RESIDENCE OF
KELLEEE RING

Project No.: The Tanglewood-Mirror
DATE: JANUARY 3, 2022
DRAWN BY: Steven Madden
DESIGNED BY: Steven Madden

Sheet Title
FLOOR PLAN

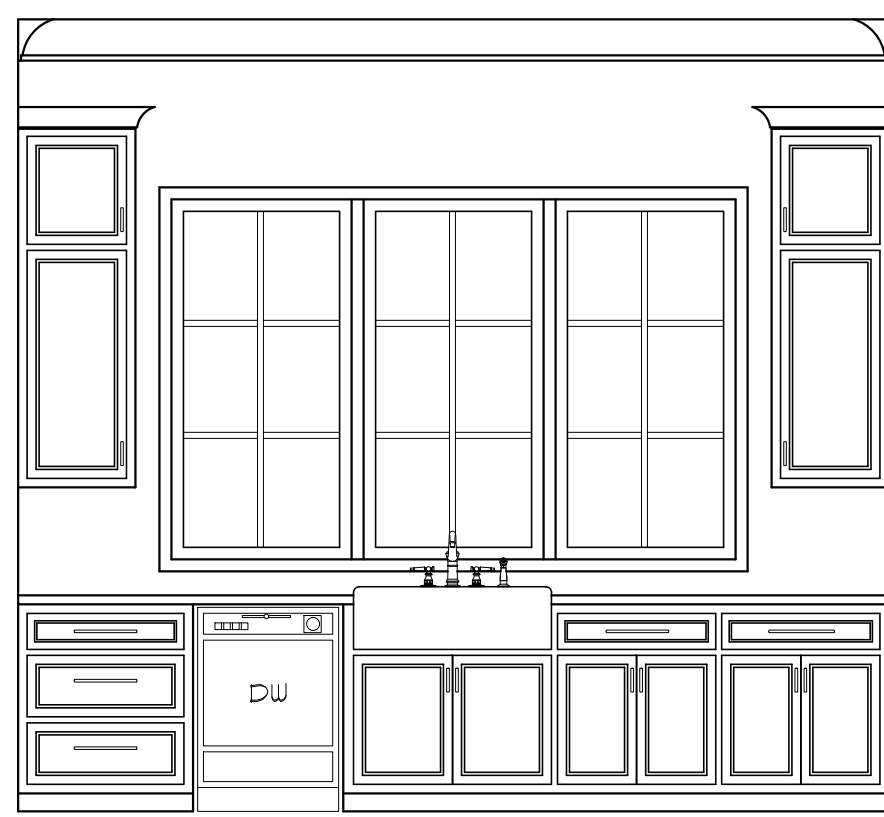
Size LVL here

size lvl to carry rafter knee wall load

size lvl to carry rafter knee wall load

Size LVL here

size TGIs for garage

Size LVL here

Size LVL here

ROOF PLAN

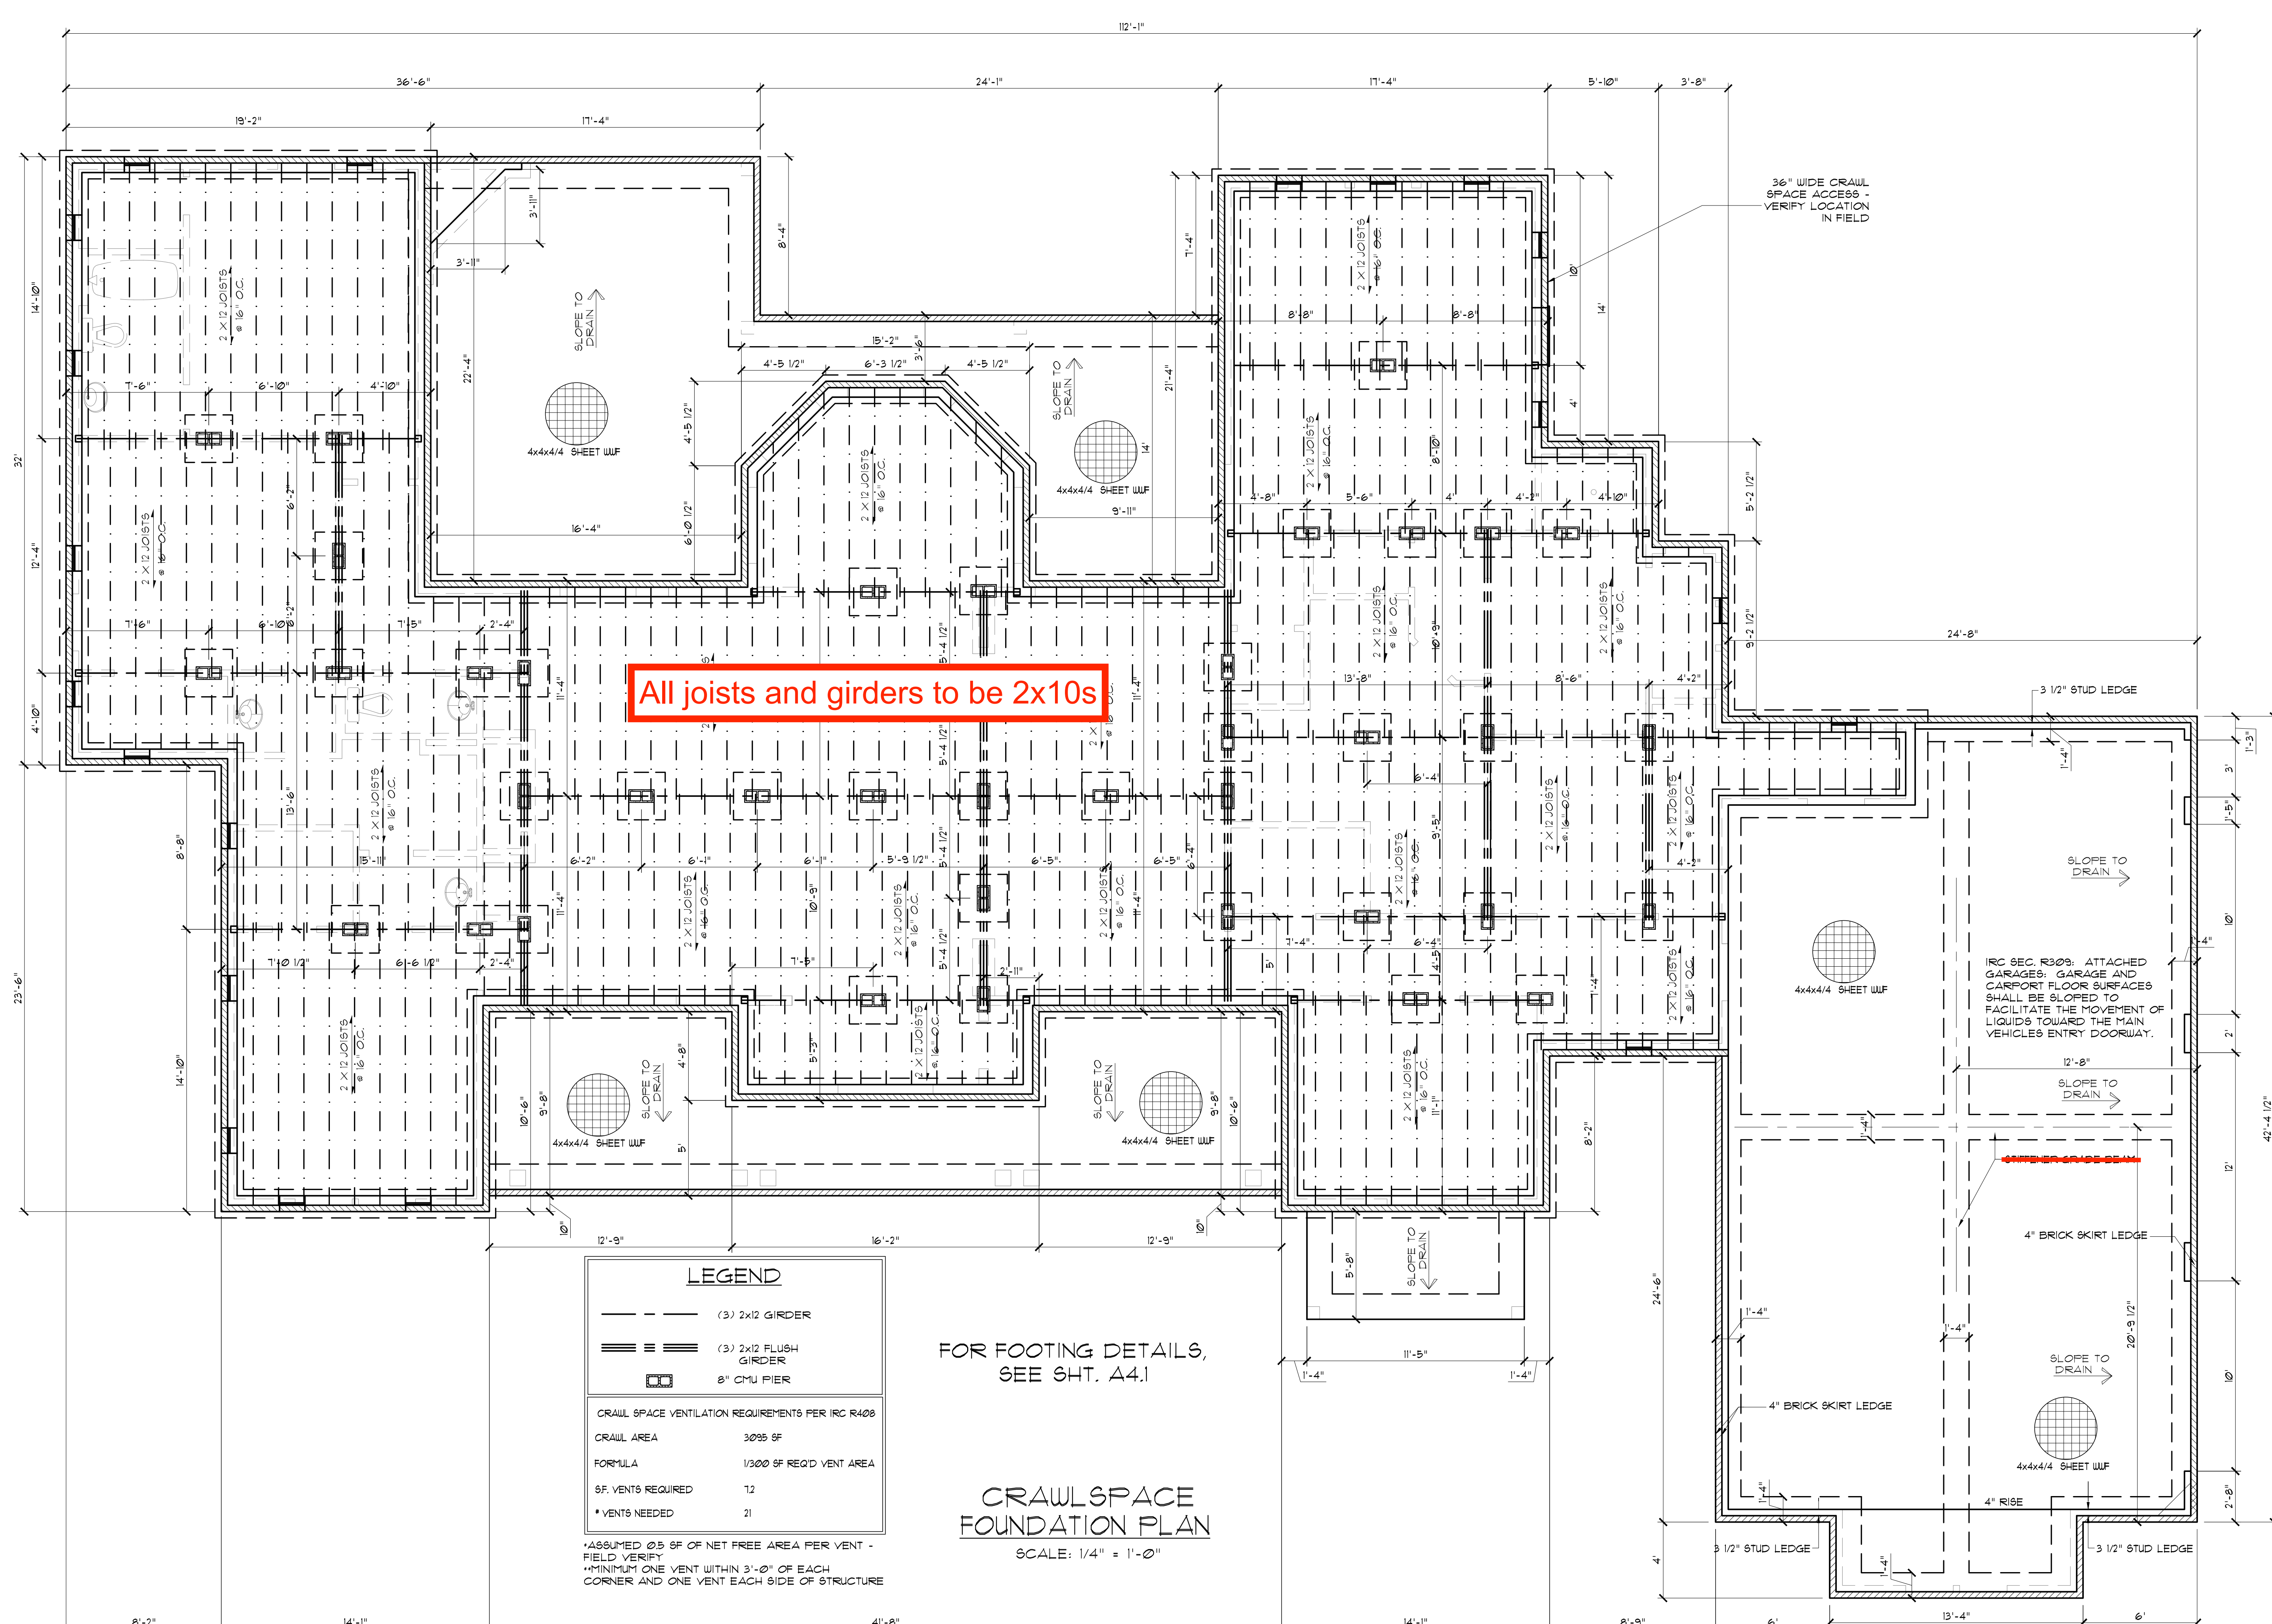
All rafters 2x8, unless otherwise noted.
 All ridge beams single 2x10, unless otherwise noted.
 Following NC Building Code, as opposed to drawing charts.

JOISTS FRAMING PLAN

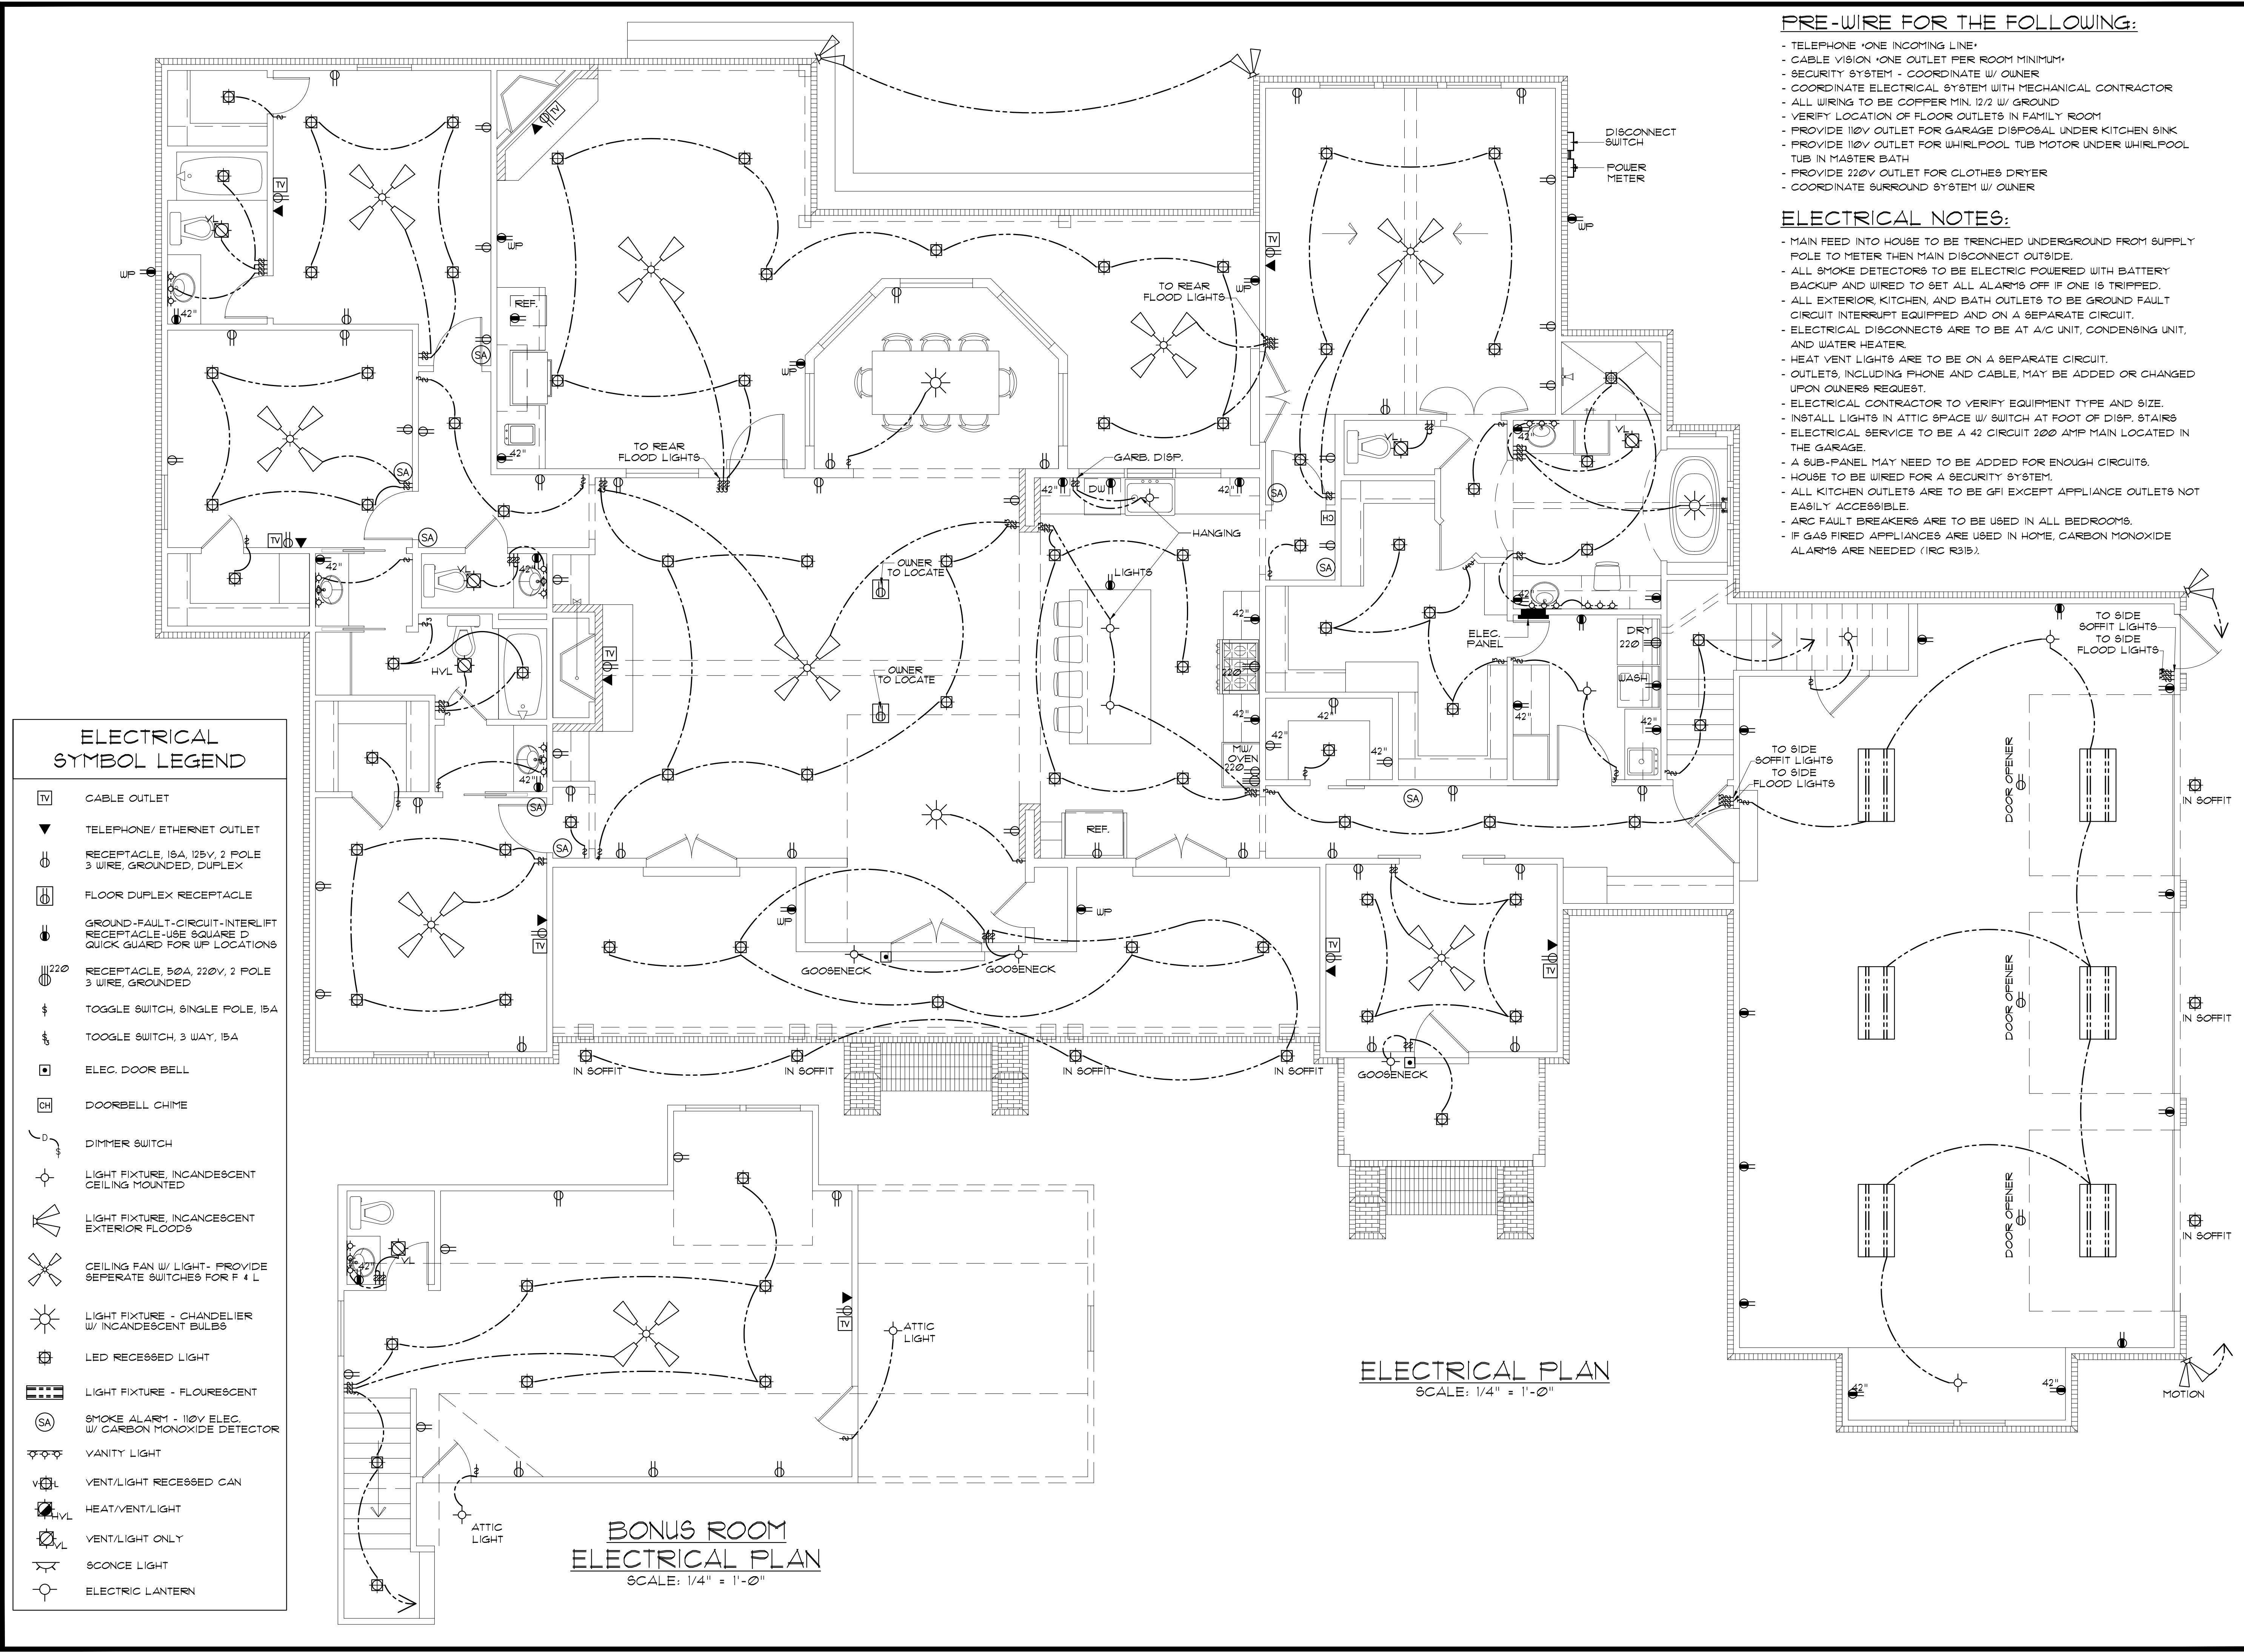
All joists and girders to be 2x10s
